CONSENSUS PLANNING agent(s) for DOUBLE CHEESE CORPORATION/BLACK DEVELOPMENT TWO request the above action(s) for all or a portion of Tract(s) 2A & 3E-1, **Black Ranch**, zoned SU-1 for C-1 Permissive Uses & Hotel Not To Exceed Two-Stories and Restaurant w/Full-Service Liquor (6.4 acres) and SU-1 for C-2 (1.4 acres), located on COORS BOULEVARD NW, between PASEO DEL NORTE NW and IRVING BOULEVARD NW, containing approximately 8 acre(s).(C-13) Deborah Stover, Staff Planner

FILE: **Project 1001206**
02EPC-01345 Site Development Plan-
Building Permit
02EPC-01346 Site Development Plan-
Amendment to Subdivision

On October 17, 2002 the Environmental Planning Commission voted to approve Project 1001206/02EPC-01346, a request for site development plan for subdivision, for Tract 2A, Black Ranch, zoned SU-1 C-1 Permissive Uses and Hotel Not To Exceed 2-Stories and Restaurant with Full-Service Liquor based on the following Findings and subject to the following Conditions:

On October 17, 2002 the Environmental Planning Commission voted to approve Project 1001206/ of 02EPC-01345, a request for site development plan for building permit, for Tract 2A, zoned SU-1 C-1 Permissive Uses and Hotel Not To

ISSUE DATE: 28 AUG 02
 REVISIONS:
 PROJECT: Landscape Plan
 SHEET: 3
 SCALE: 1"=30'

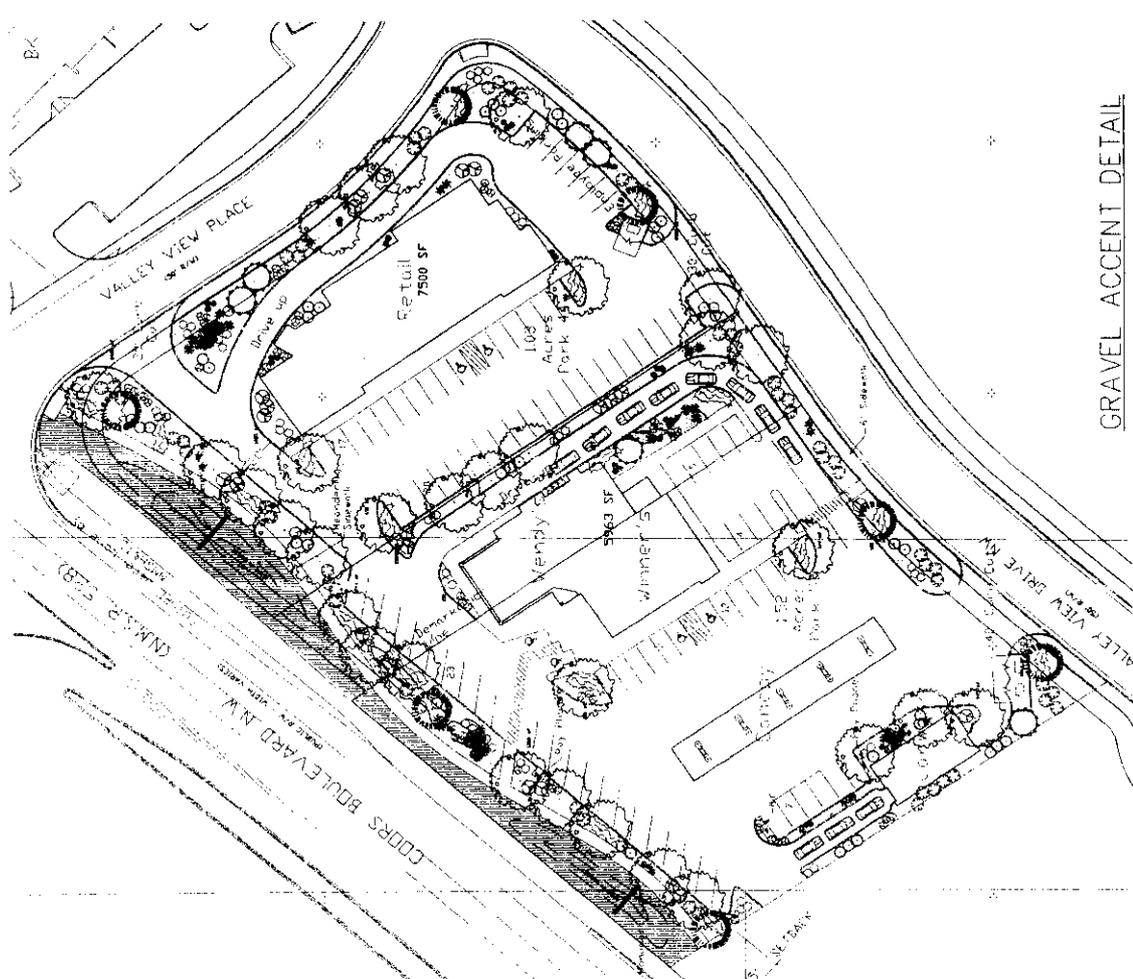
- b. A third species of shade tree shall be introduced into the tree palette to ensure survival of a healthy tree canopy. The landscape plan shall provide for Chinese pistache or similar tree in addition to the proposed ash and Honey locust species. The site plan shall state ash 'and' Honey locust or Chinese pistache, not 'or'.

- c. The site plan for building permit states that the amount of landscaping provided is 28,070 square feet while the landscaping plan states that 21,381 square feet is provided. The landscape calculations shall match on both plans.

- d. The percentage of landscaping provided shall listed on the landscape plan.
 - e. The note that states "Final landscaping layout and design to be determined upon receipt of final grading plan" shall be removed from the landscaping plan.

Site Development
 Plan
 SHEET 5

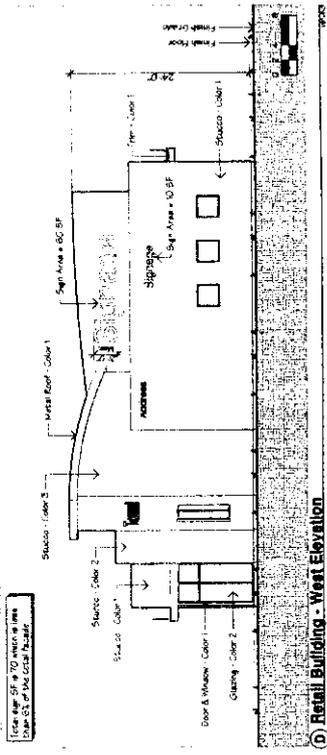
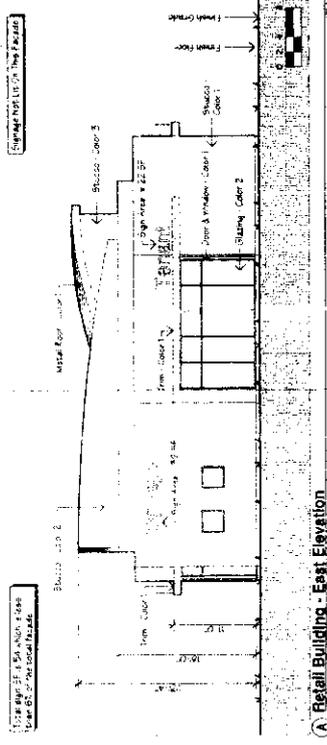
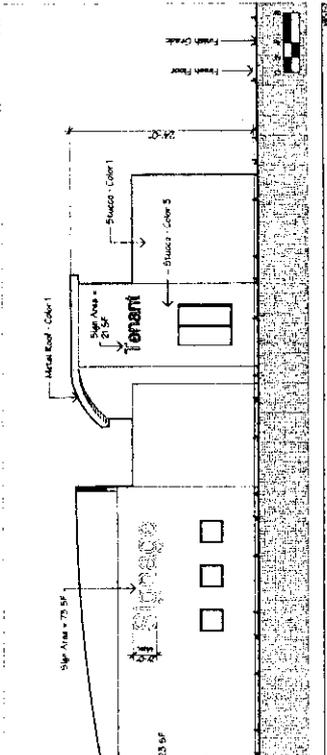
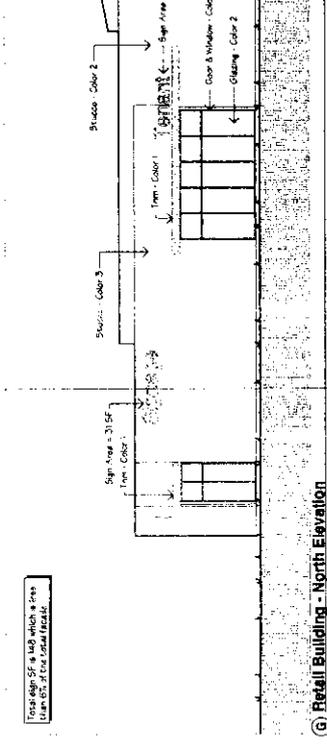
8. Elevations:
 - a. The color of the roof material shall be specified on the plans.
 - b. The elevation for the Wendy's/Winner's are labeled incorrectly, as the drive-through window for Wendy's is on the north side, not the south side. These labels shall be correctly adjusted.

- c. No lighted signs shall be placed on east-facing buildings or in a location that is visible from residential areas east of this development.
 - d. Notes shall be added that clarify the materials and corresponding colors for the fueling canopy.

Site Development
 Plan
 SHEET 6
 OF 7

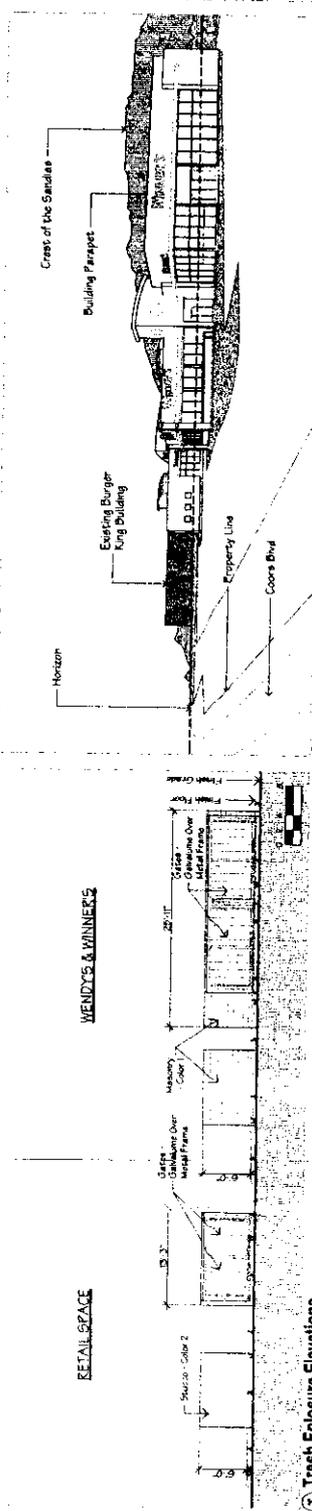
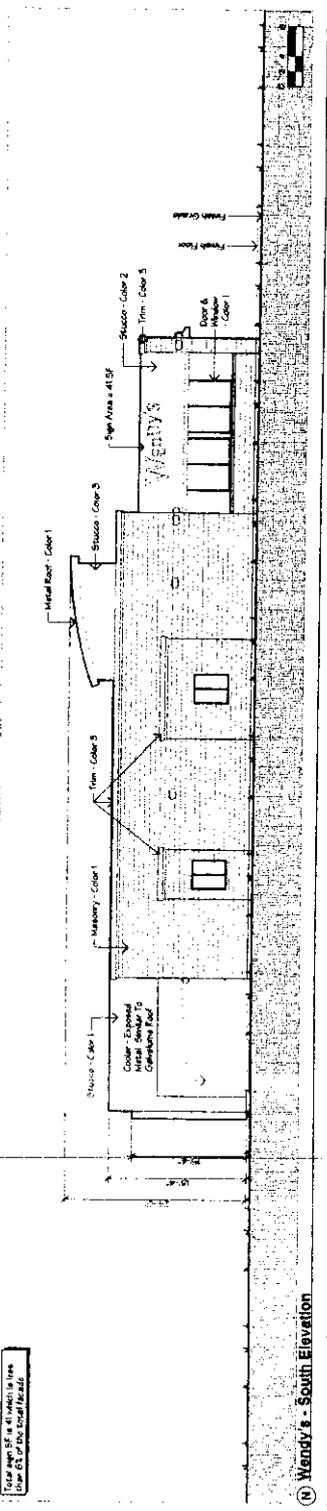
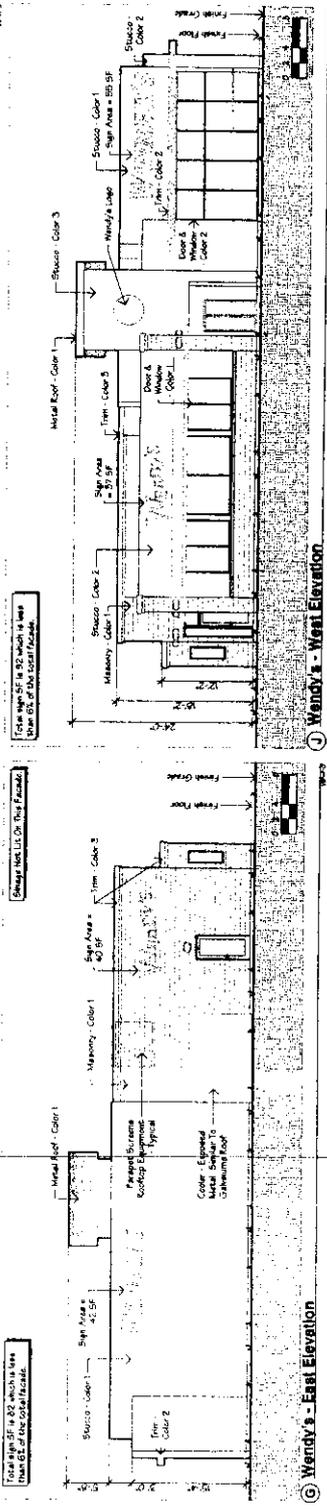
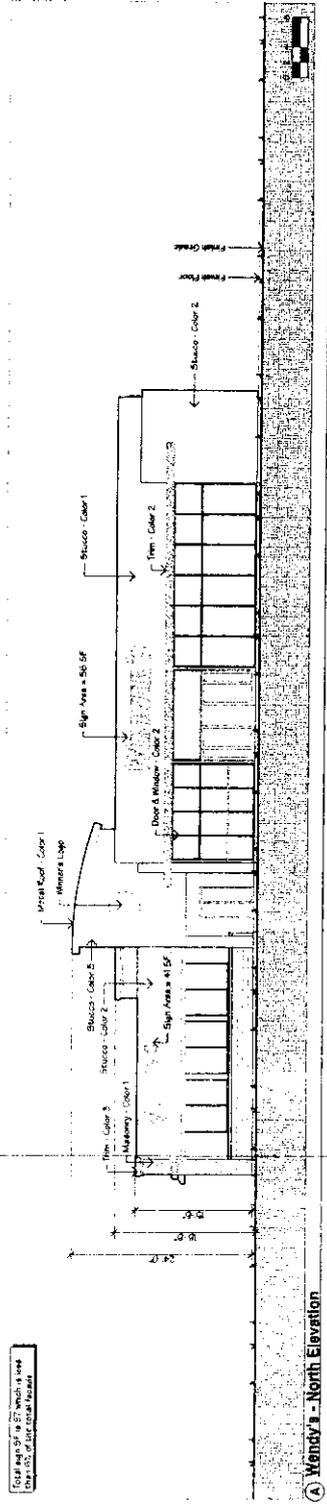
- e. A note shall be added that states that the underside of the fueling canopy shall not be of a material that is a reflective surface.
9. A cross-access agreement shall be noted on the plan for this site.
